CBD AND SOUTH EAST LIGHT RAIL PROJECT

STATE SIGNIFICANT INFRASTRUCTURE APPROVAL (SSI-6042)

SUBMISSIONS REPORT TO PROJECT MODIFICATION

JANUARY 2015

Figure 6.1 Clarification on the position of the turn back track at Royal Randwick Racecourse stop

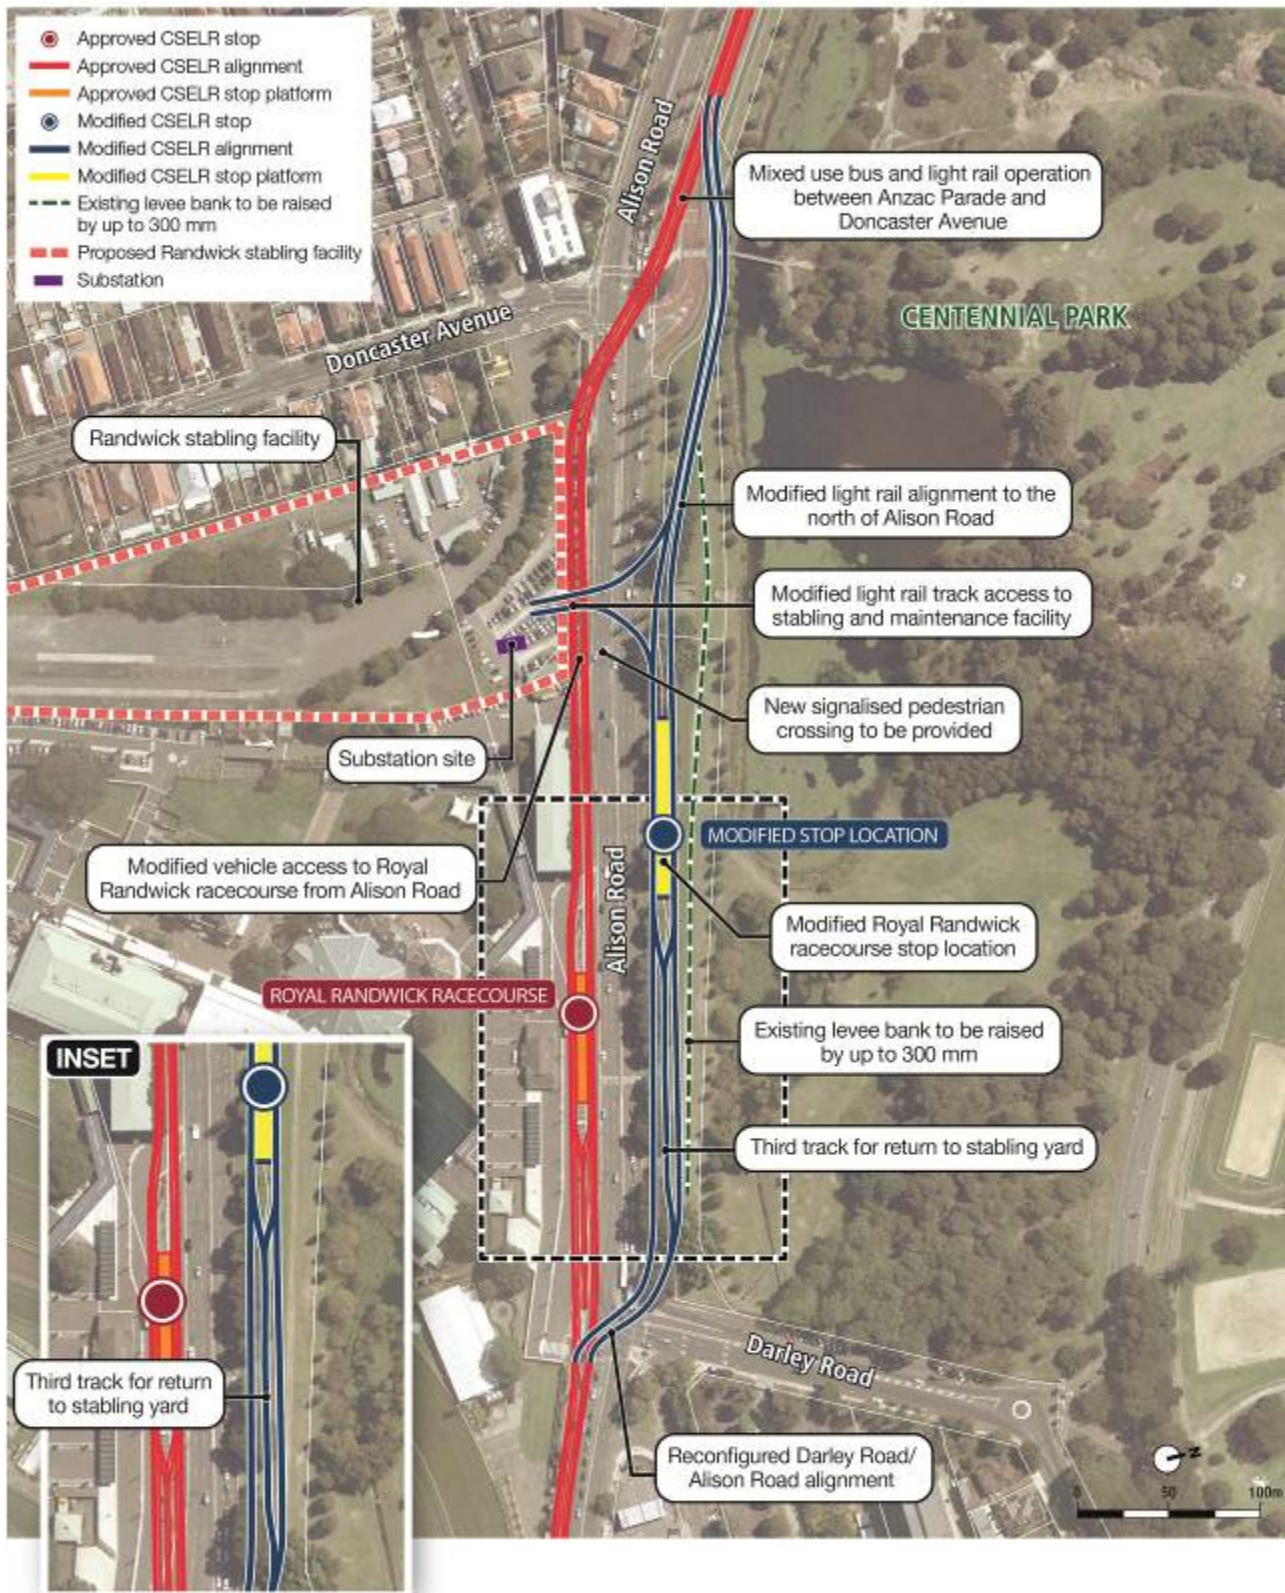
| Specific issues raised in submissions | Response to specific issues | Submission No. |
|-----------------------------------------------------------------------------------------------------------------------------------------------------------------------------------------------------------------------------------------------------------------------------|------------------------------------------------------------------------------------------------------------------------------------------------------------------------------------------------------------------------------------------------------------------------------------------------------------------------------------------------------------------------------------------------------------------------------------------------------------------------------------------------------------|----------------|
| Figure 3.19 in the Modification Report shows a broken blue line beside the 2 rail tracks. Respondent believes that this indicates a 3rd rail track, for use if an extra train is needed for a major event. Given that, how much further into Centennial Park is land taken. | <p>Chapter 6 of this Submissions Report provides some clarifications, including clarification on the figure in question. The broken blue line shown on the Figure 3.19 in the Modification Report indicates the location of the proposed levee bank to be raised.</p> <p>The CSELR is proposed to be located within Centennial Park land. The precise area to be acquired for this project would be determined through negotiations with the Centennial Park Trust during the detailed design process.</p> | 88 |

Figure 3.19 of the Project Modification Report identified two tracks running parallel to the northern side of Alison Road between the entry to the Randwick stabling facility and Darley Road.

The revised figure which outlines the track arrangement along Alison Road to allow improved access into the Randwick stabling facility is shown in Figure 6.1 below.

Figure 6.2 Clarification on planted tree impacts along Alison Road realignment

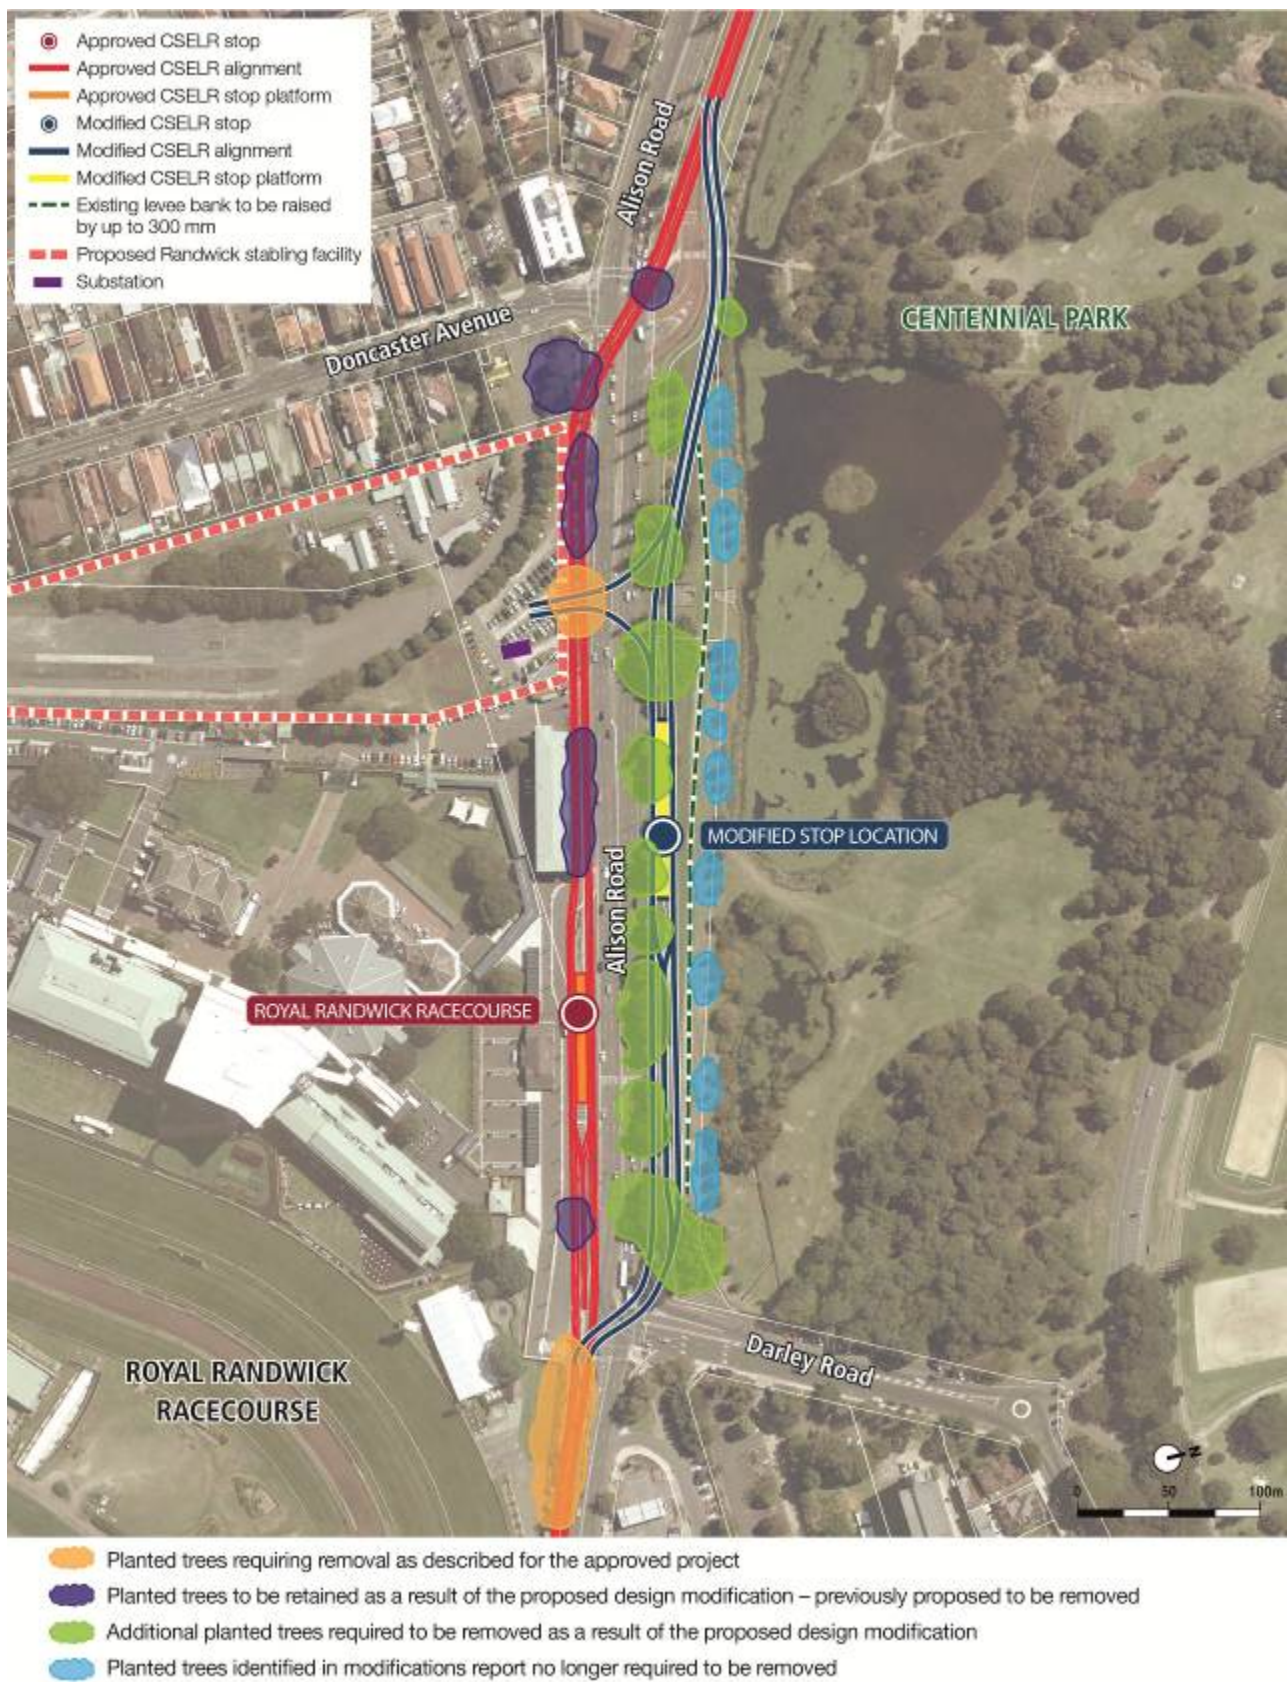
Figure 3.22 of the Project Modification Report outlines the potential impacts to vegetation and planted trees along Alison Road. Since the exhibition of the Modification Report, ongoing design development has identified that a reduction in the number of trees is expected to be affected by the proposed modification. Notably, this includes the retention of many of the 'Maidens Row' paperbark trees located between Alison Road and the western edge of Kensington Ponds in Centennial Parklands.

The revised figure which outlines the trees to be retained is shown in Figure 6.2 below.
